LINCOLN PARK PLANNING COMMISSION

970 Fort Street – Auto Sales and Services

Site Plan Review

Applicant	Mohammed Aoude
Project	Auto Sales and Service
Address	970 Fort Street, Lincoln Park, MI 48146
Date	September 9 2020
Request	Final Review – Special Land Use
Recommendation	Approve with Conditions

DATE: 07/08/2019
DRAWN BY: MONEER ALAHWAL
SCALE: AS NOTED
SHEET TITLE: - PROPOSED SITE PLAN
SHEET #: SP-2
APPROVED BY:

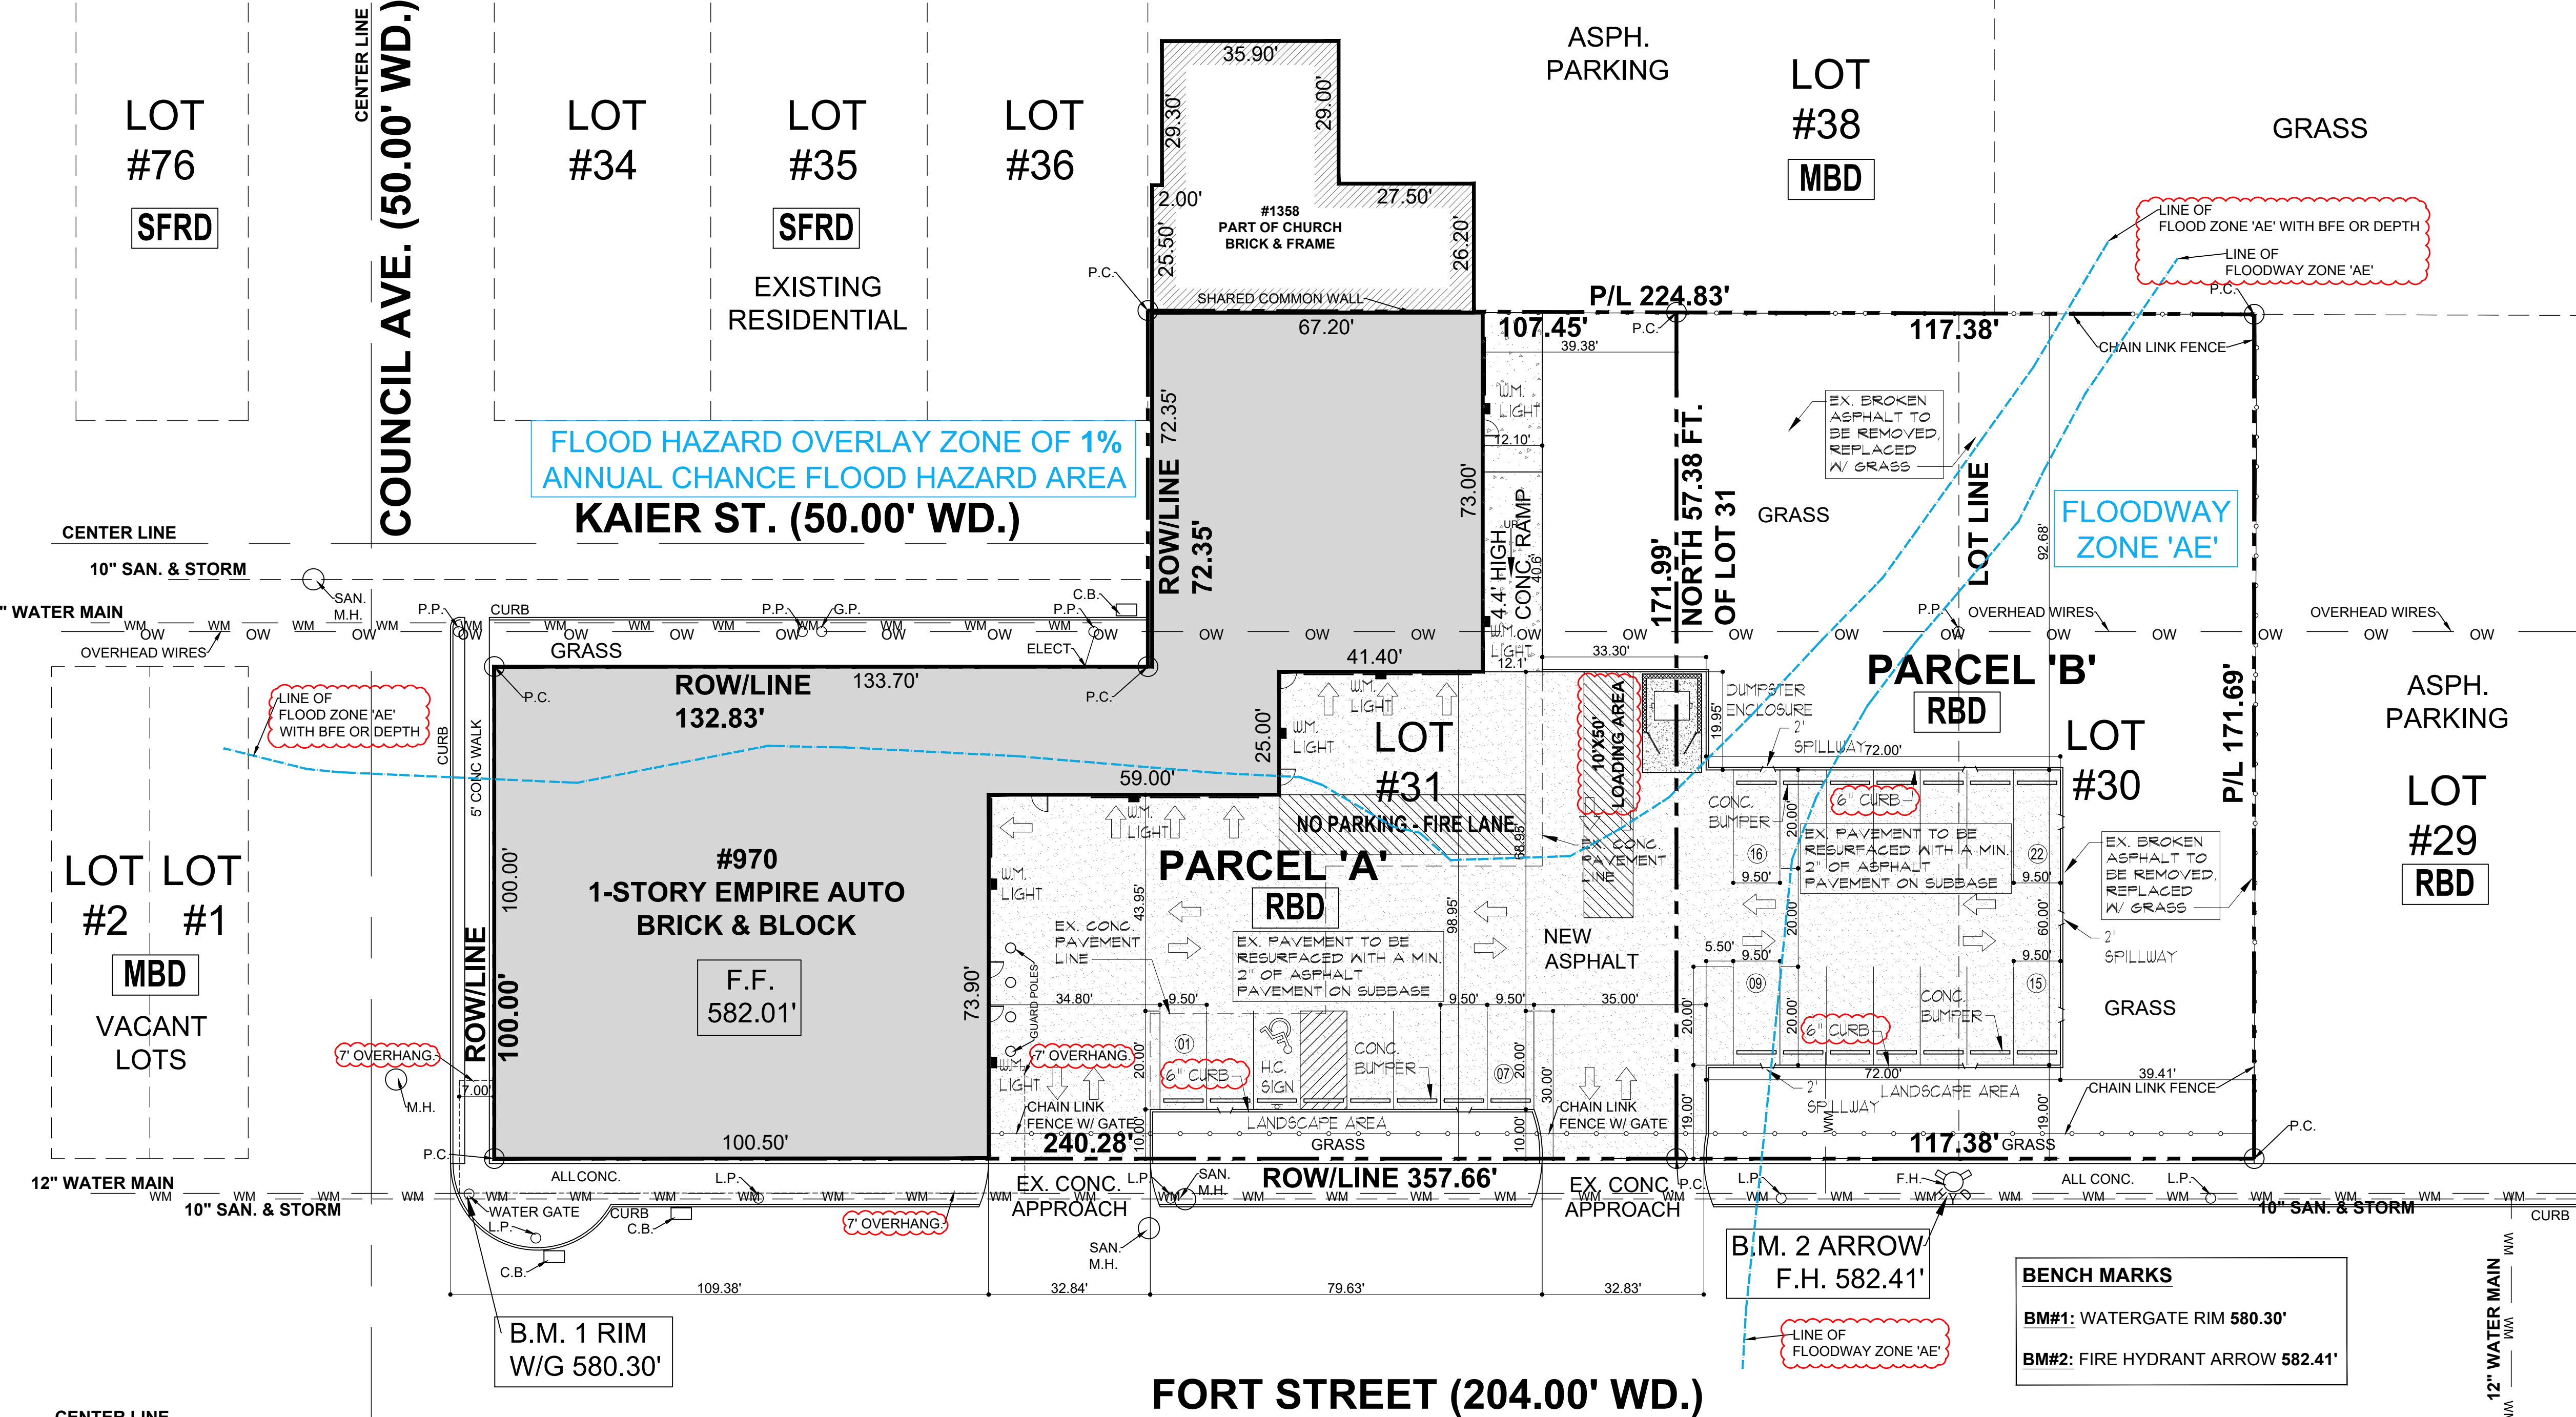
1. The plans acknowledge the site is in a flood plain. They do not indicate part of the site is in a floodway. The flood plain and floodway should be clearly indicated on the site plan.
2. Work within the flood plain may require an EGLE/CORP joint Permit. Any work in the floodway will require an EGLE/CORP joint Permit.
3. In the engineer's review, the engineer must verify that the finish floor is above the flood plain elevation. If possible a LOMA or LOMR may need to be filed.

1. The southerly drive approach is broken and will need to be replaced.
2. The proposed work in the parking lot will need to be evaluated during the detailed engineering site plan review

- Driveways and curb cuts are larger than permitted by either 1290.10 or 1294.14, and curb cuts exceed the maximum number permitted. The site plan shall be revised to close one curb cut.*
- Applicant shall provide concrete raised curb (6) inches along the landscaped areas.*

The second curb cut is prohibited by ordinance, and does not appear to be critical to the site's internal circulation. A revised site plan shall show a single curb cut.

- Site plan shall clearly indicate the floodplain and floodway.*
- Applicant shall verify that the finish floor is above the floodplain elevation. If possible, a LOMA or LOMR may need to be filed.*
- Applicant shall obtain permits from the Michigan Department of Environment, Great Lakes, and Energy (EGLE)/CORP for work within the floodplain as required, and for any work within the floodway.*

- Planning Commission waiver sought to reduce the number of required parking spaces from 25 to 21 (provides 84% of requirement)*
- Broken south drive approach shall be removed or replaced.*
- Proposed work in parking lot will be evaluated for adequacy during detailed engineering review; if parking lot conditions prove too deteriorated for successful resurfacing as proposed, the lot shall be reconstructed.*

- Site plan shall clearly indicate the floodplain and floodway.
- Driveways and curb cuts are larger than permitted by either 1290.10 or 1294.14, and curb cuts exceed the maximum number permitted. The site plan shall be revised to close one curb cut.
- Applicant shall provide concrete raised curb (6) inches along the landscaped areas.

DATE: 07/08/2019
DRAWN BY: MONEER ALAHWAL
SCALE: AS NOTED
SHEET TITLE: - PROPOSED LANDSCAPE & LIGHTING PLANS
SHEET #: SP-3
APPROVED BY:

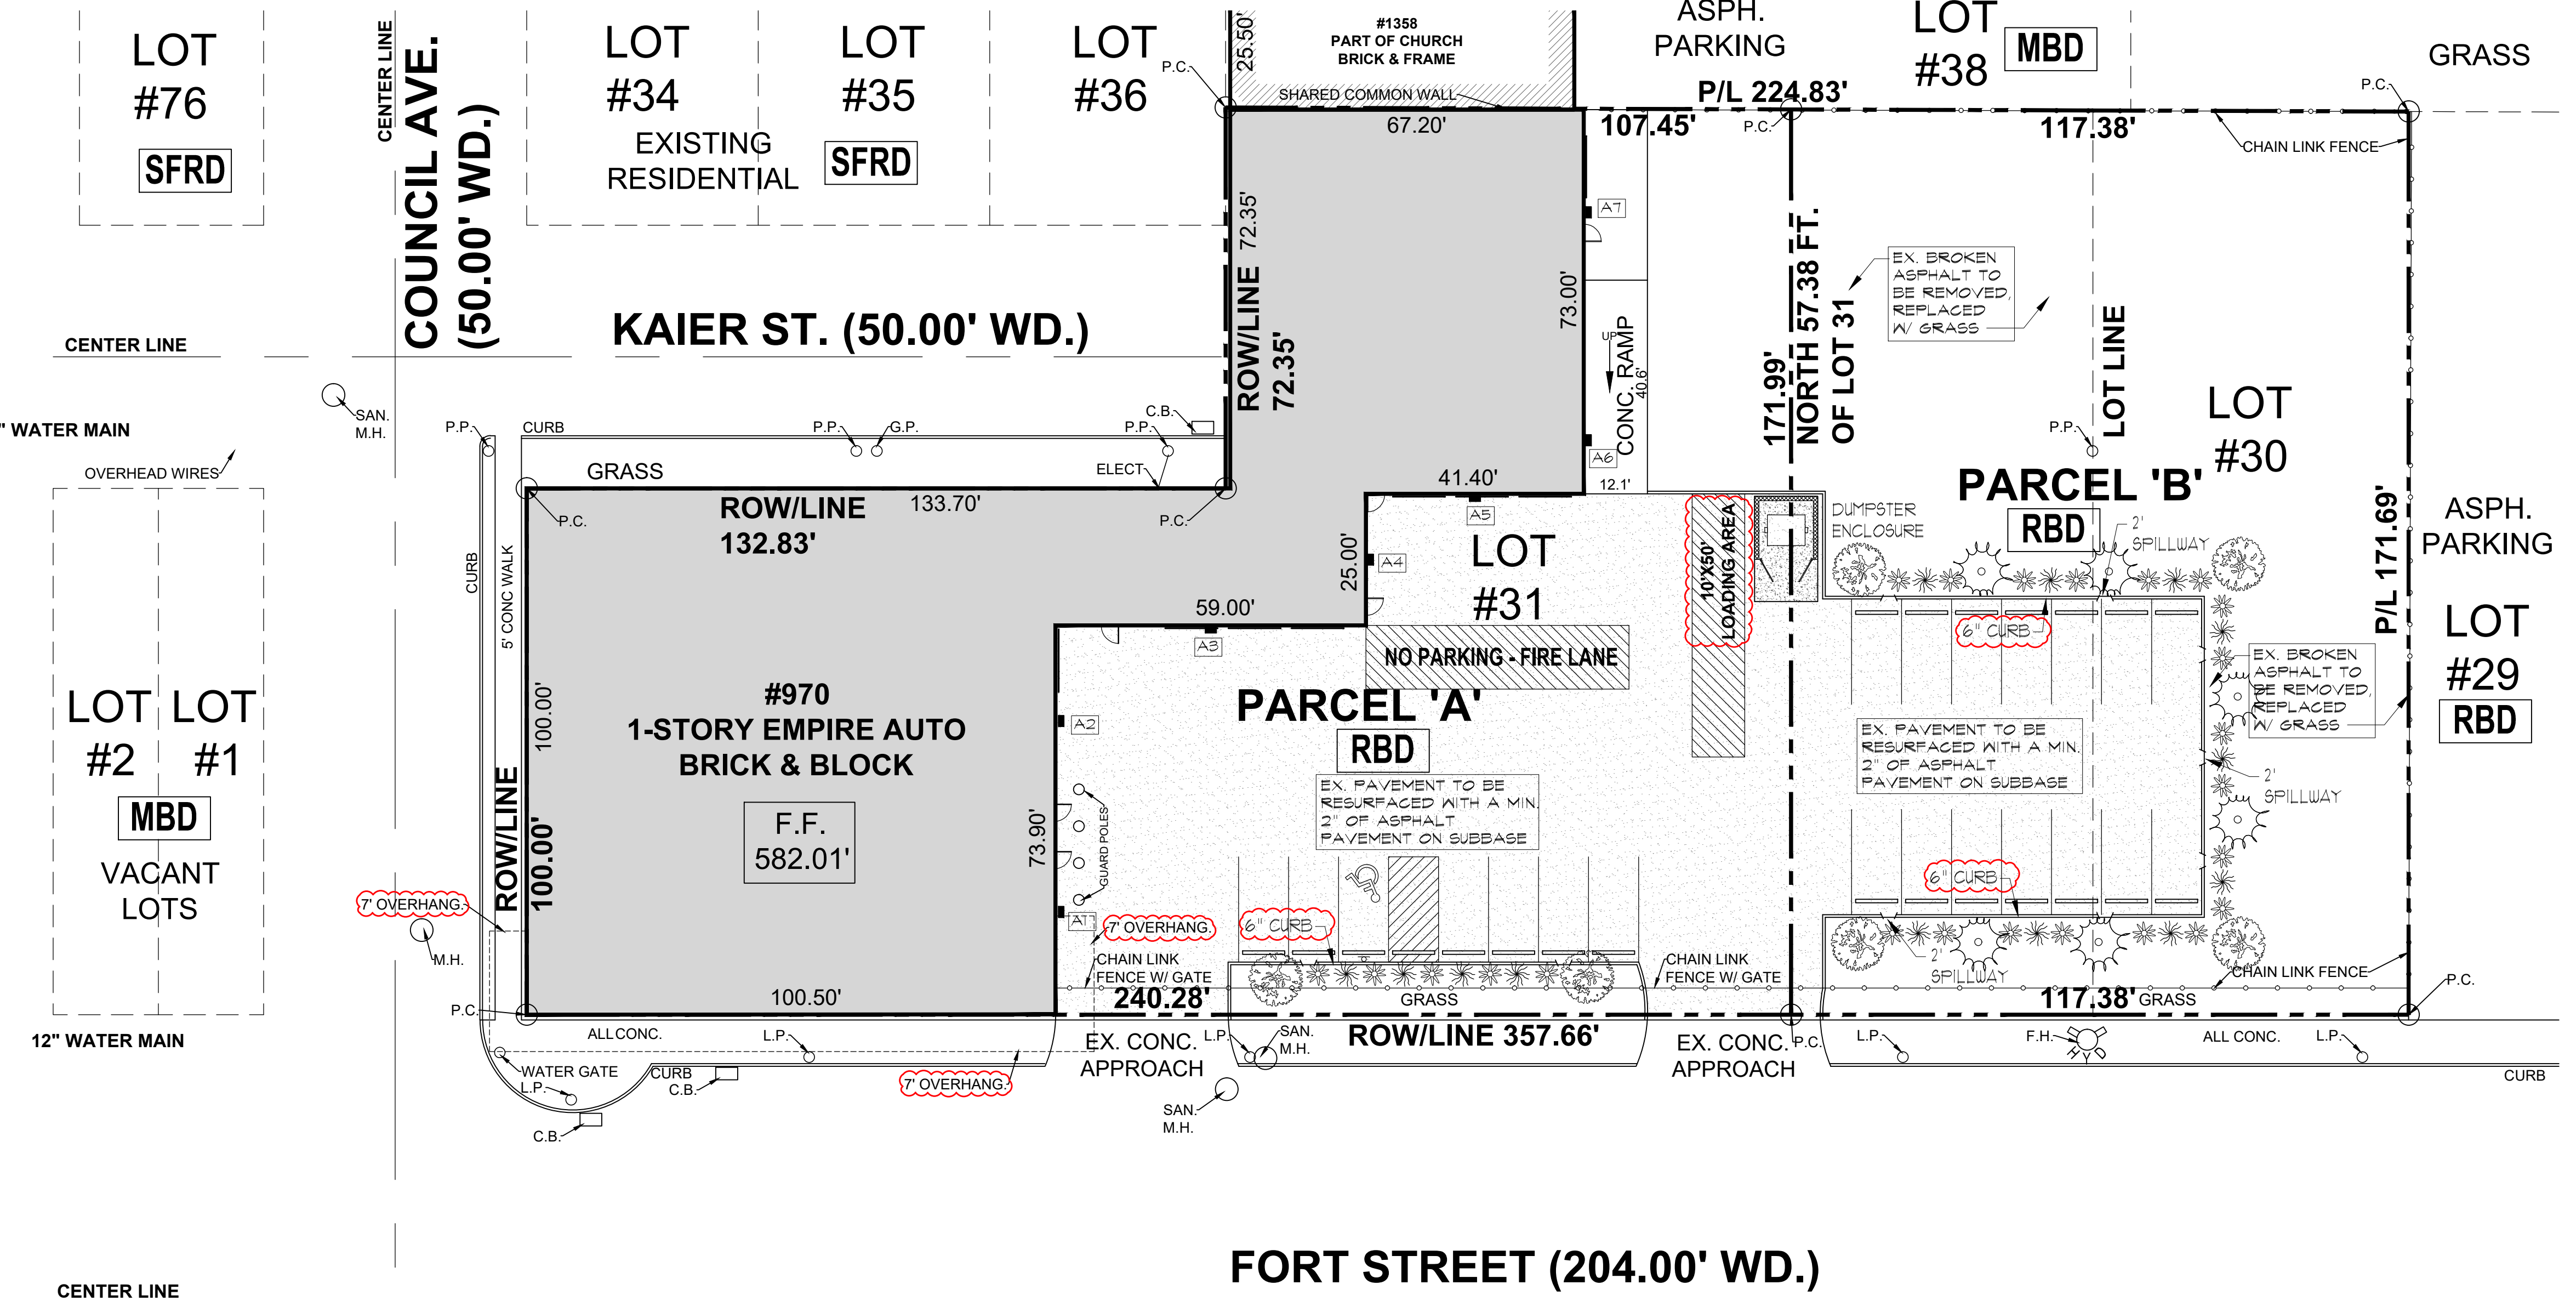
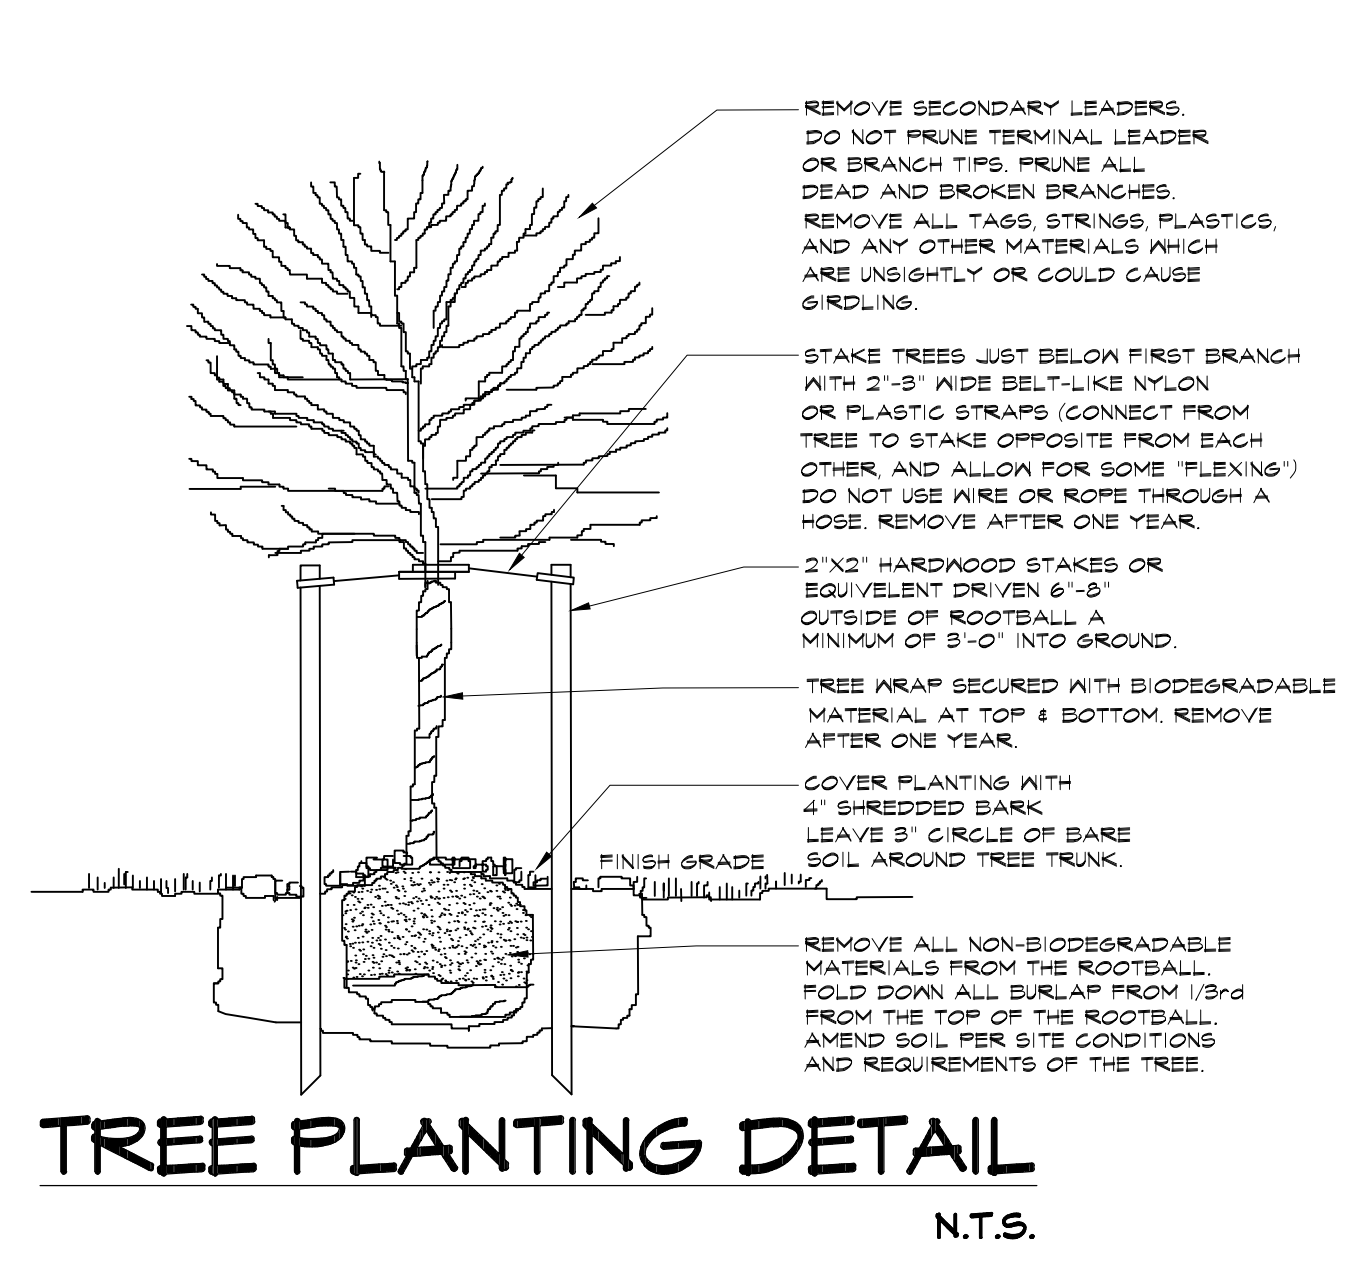
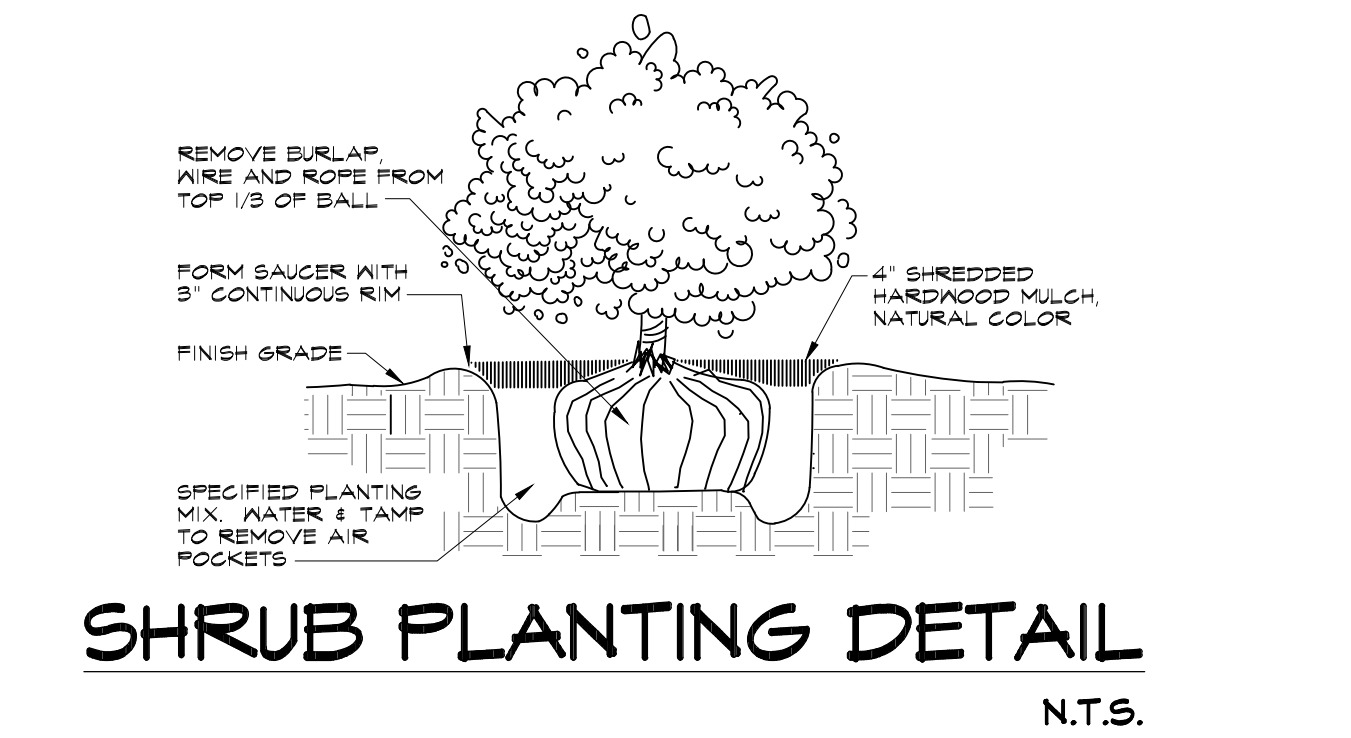
Required	Proposed	Compliance
Parking Lot	1 deciduous or ornamental tree per 10 parking spaces <i>21/10 = 3 trees</i>	9 trees surround the parking lot	MET
	100 sf of planting area per tree	Trees are located within Parcel (B) without planters	MET
Screening	Waste receptacle: Decorative masonry wall of at least 6' with solid or impervious gate	Provided	MET
	Abutting residential: greenbelt, 15' with 5' evergreens (PC may waive); solid 6' masonry wall ornamental on both sides	Not Applicable	NOT APPLICABLE
